TECHNICAL SERVICE BULLETIN

Torque-On-Demand (TOD) Transfer Case - Grinding/Clicking/Ratcheting Noise From Front Wheel Area

20-2307

15 October
2020

Figure 2

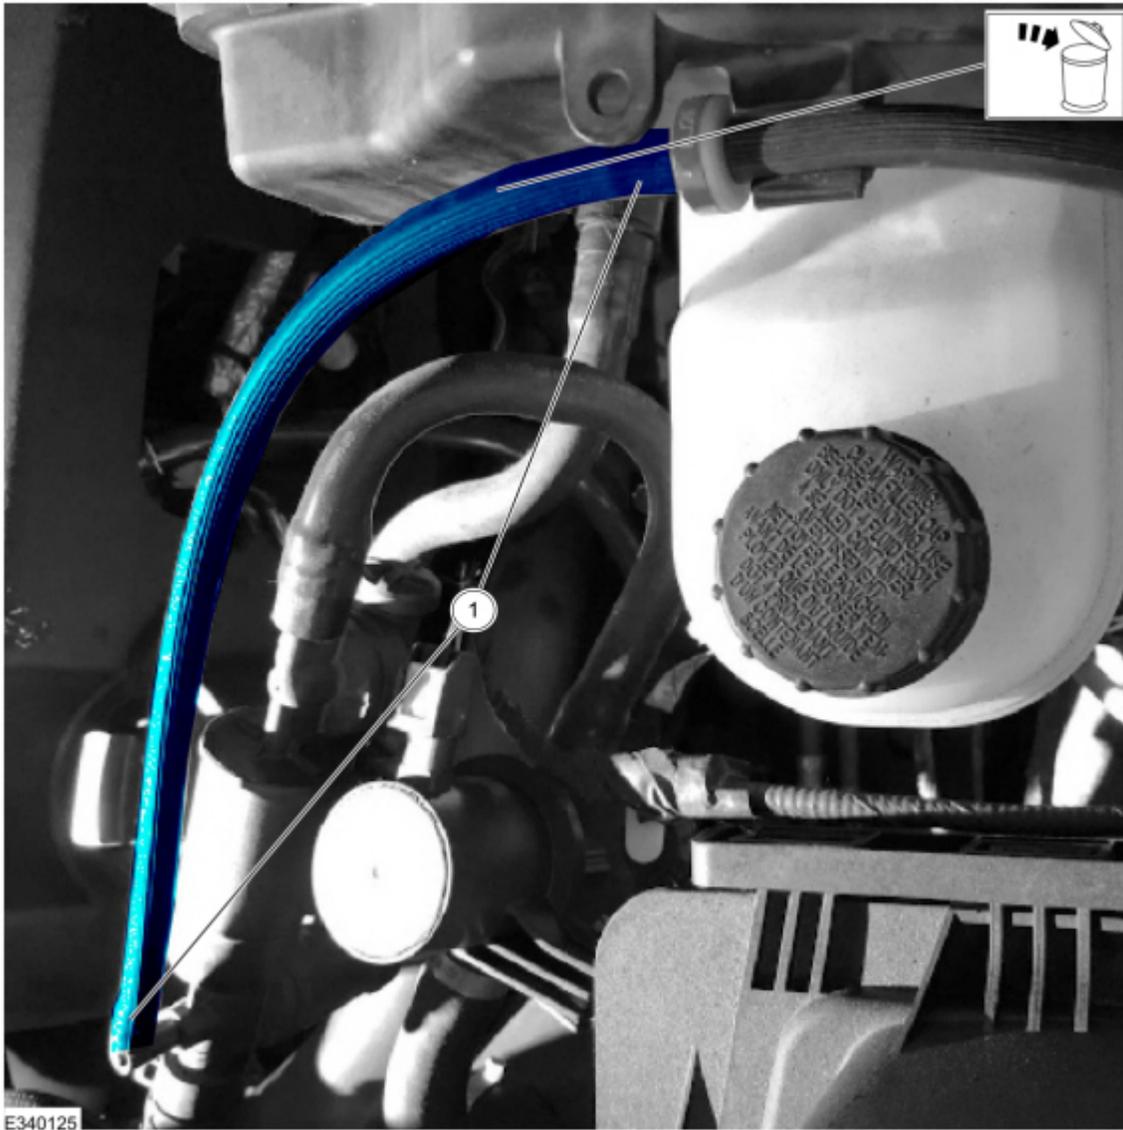
2. Locate the vacuum supply line between the source vacuum and the IWE check valve. Refer to WSM, Section 308-07A. (Figures 2-3)

3. Remove the vacuum supply line.
4. Install the vacuum caps at the IWE check valve and the vacuum source.
